Bulletin Number: 88-7-4
 Reference Number: 877204R
 Publish Date: 10/87

Subject: FLUID LEAK FROM THE FLUID LEVEL INDICATOR ASSEMBLY BORE

Models Affected: 1988 6000, SUNBIRD, GRAND AM, AND FIERO MODELS EQUIPPED WITH HM-282 MANUAL TRANSAXLE (RPO MG1 AND MG2) 1988 DAS, 8ZP, 8ZR, 8ZN, ZZJ AND 8ZL

Figure 2 - Fluid Level Indicator Assembly And Bore

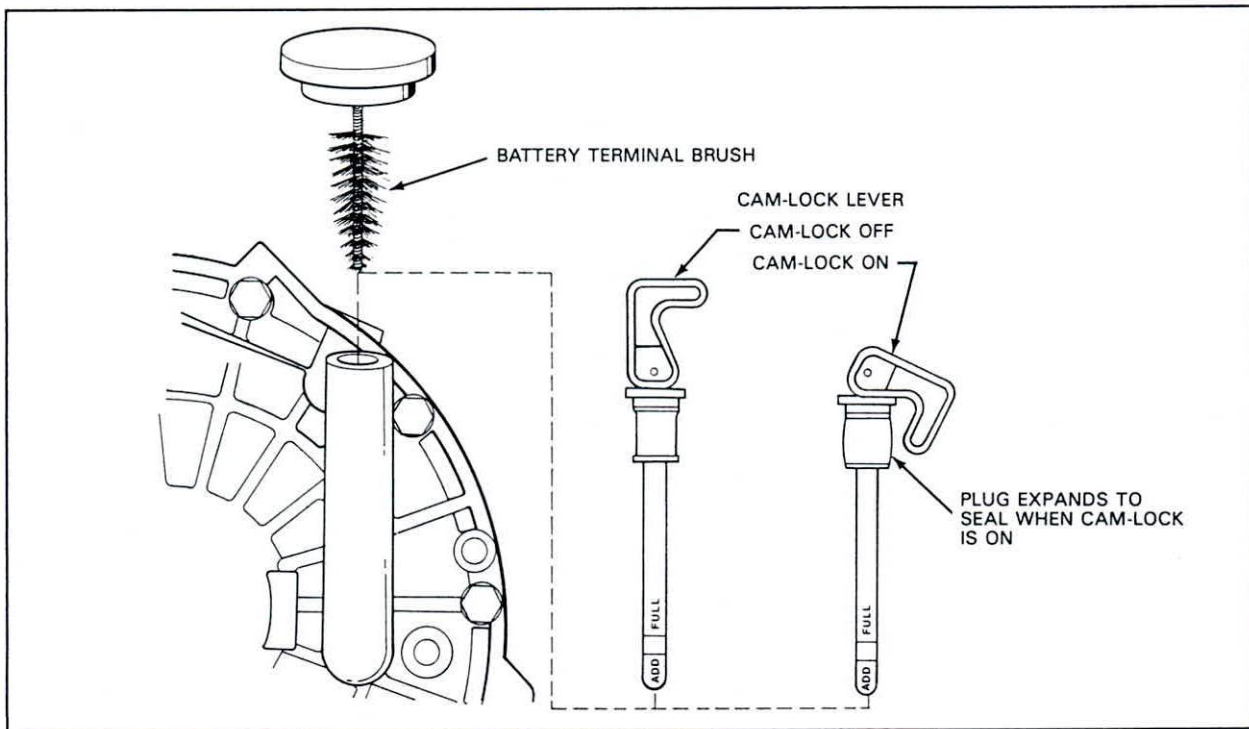
If this condition is encountered, try to pull out the indicator (with the cam-lock on). If the indicator pulls out install the updated design fluid level indicator assembly (estimated availability for service December, 1987). The updated design has four grooves in the plug to help "grab" on the bore. The new indicator will also have an expanded "OK" fluid level section that is crosshatched.

If the updated design indicator is not available then the fluid level indicator bore will have to be "roughed" up so the plug of the old design will "grab" on the bore. To service, perform the following procedure.

1. Release the cam-lock then remove fluid level indicator assembly.
2. Wipe indicator bore with Synchronesh Transmission Fluid (STF).
3. Put a new battery terminal brush (15mm (5/8 in.) minimum diameter) into the bore and rotate at least eight complete turns.

4. Remove battery terminal brush and clean bore with a clean cloth.
5. Install fluid level indicator assembly.
6. Check for proper fit by trying to pull out the indicator with the indicator cam-lock on.
 - If the indicator can be pulled out, repeat the above procedure.
